## DESCRIPTIVE REPORT

Type of Survey ... Field Examination  
Field No. .... PE-5-1-85  
Registry No. .... FE-279

State ..... U.S. Virgin Islands  
General Locality ... St. Thomas  
Sublocality ..... West Gregerie Channel

ATLANTIC MARINE CENTER  
EVALUATION REPORT

FE-279 U.S. VIRGIN ISLANDS ST. THOMAS WEST GREGERIE CHANNEL SCALE 1:5,000 PUERTO RICO PROJECTION POLYCONIC SOUNDINGS IN FEET AT MEAN LOWER LOW WATER SMOOTH SHEET

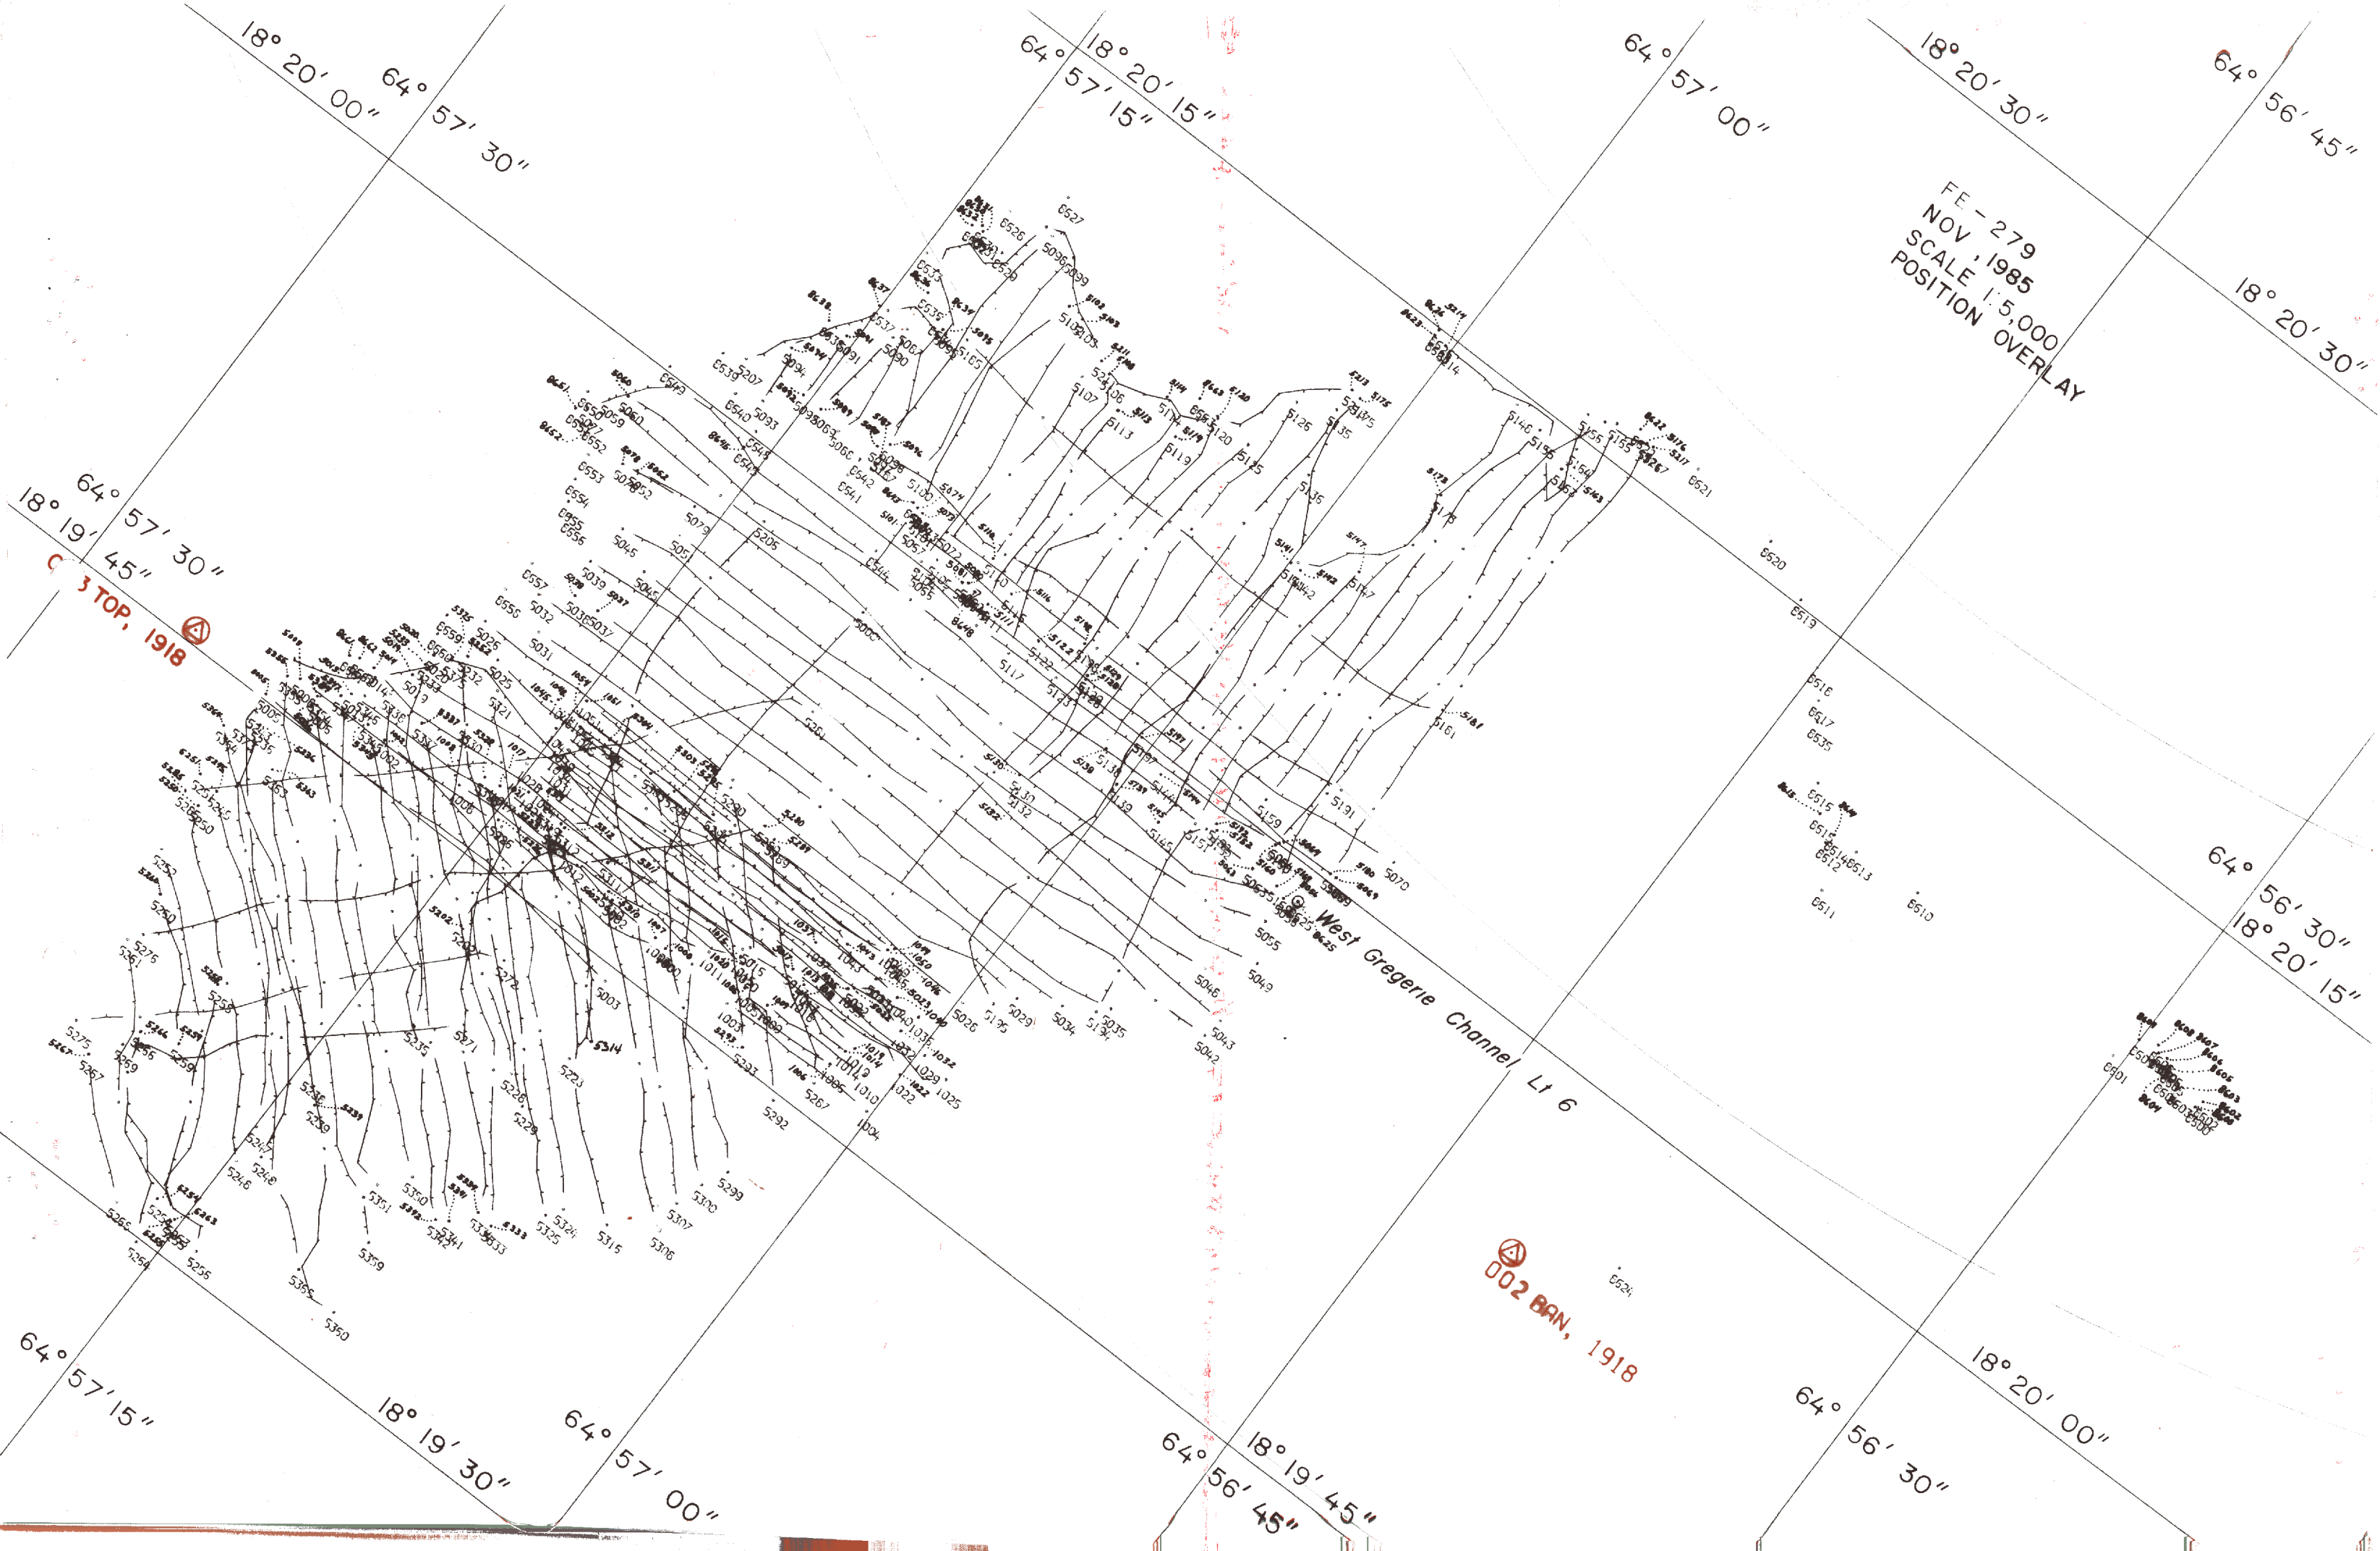
a. Control is not adequately discussed in sections F. or G. of the Descriptive Report. See sections 4.e. and 4.f. of this report.

b. Shoreline in brown originates with NOS chart 25649 (13th Edition, 30 Aug 1980) and is for orientation purposes only. Shoreline changes east of Longitude 64°57'22 are discussed by the hydrographer in section H. of the Descriptive Report. Additions or revisions by the hydrographer are shown in red on the present survey.

b. The standard depth curves could not be drawn in their entirety; the zero (0) curve was not delineated, the six (6), twelve (12), and eighteen (18) foot curves were not delineated in their entirety because of vessel safety. The thirty-six (36) foot and brown curves were added to better delineate bottom relief.

c. The development of the bottom configuration and determination of least depths is considered adequate with the following exceptions:

1) A twenty-seven (27) foot obstruction in Latitude 18°19'44.88"N, Longitude 64°57'06.20"W was not investigated by the hydrographer. The soundings on the adjacent lines of hydrography on the present survey show depths of thirty-six (36) to thirty-nine (39) feet. See also sections 7.a.1) and 9. of this report. *skul*

2) A thirty (30) foot sounding in Latitude 18°20'05.02"N, Longitude 64°57'00.70"W was not investigated by the hydrographer. The soundings on the adjacent lines of hydrography on the present survey show depths of thirty-three (33) to thirty-six (36) feet. ✓

3) Thirty-five (35) and thirty-nine (39) foot soundings in Latitude 18°19'43.23"N, Longitude 64°57'13.73"W, and Latitude 18°19'44.07"N, Longitude 64°57'13.78"W, respectively, were not investigated by the hydrographer. Soundings on adjacent lines of hydrography on the present survey show depths of thirty-eight (38) to fifty-two (52) feet. ✓

Additional lines of hydrography in the vicinity of the soundings discussed above would have provided a better delineation of the bottom configuration. The lack of development of items discussed above does not degrade the overall quality of the survey.

The smooth sheet and accompanying overlays, hydrographic records and reports are adequate and conform to the requirements of the HYDROGRAPHIC MANUAL with the following exceptions:

a. The field unit failed to determine bottom characteristics as required by section 6.7. of the Project Instructions, and sections 1.6.3 and 4.7.1 of the HYDROGRAPHIC MANUAL.

b. The field unit failed to determine a least depth on the thirty (30) foot shoal, and thirty-six (36) foot shoal in the vicinity of Latitude 18°19'40"N, Longitude 64°57'12"W, and Latitude 18°20'03"N, Longitude 64°57'00"W, respectively, as required by section 1.4.3. of the HYDROGRAPHIC MANUAL.

h. The field unit, while jogging to avoid traffic, created several holidays in survey coverage. The field unit did not run additional lines of hydrography to fill the holidays as required by section 4.5.2. of the HYDROGRAPHIC MANUAL.
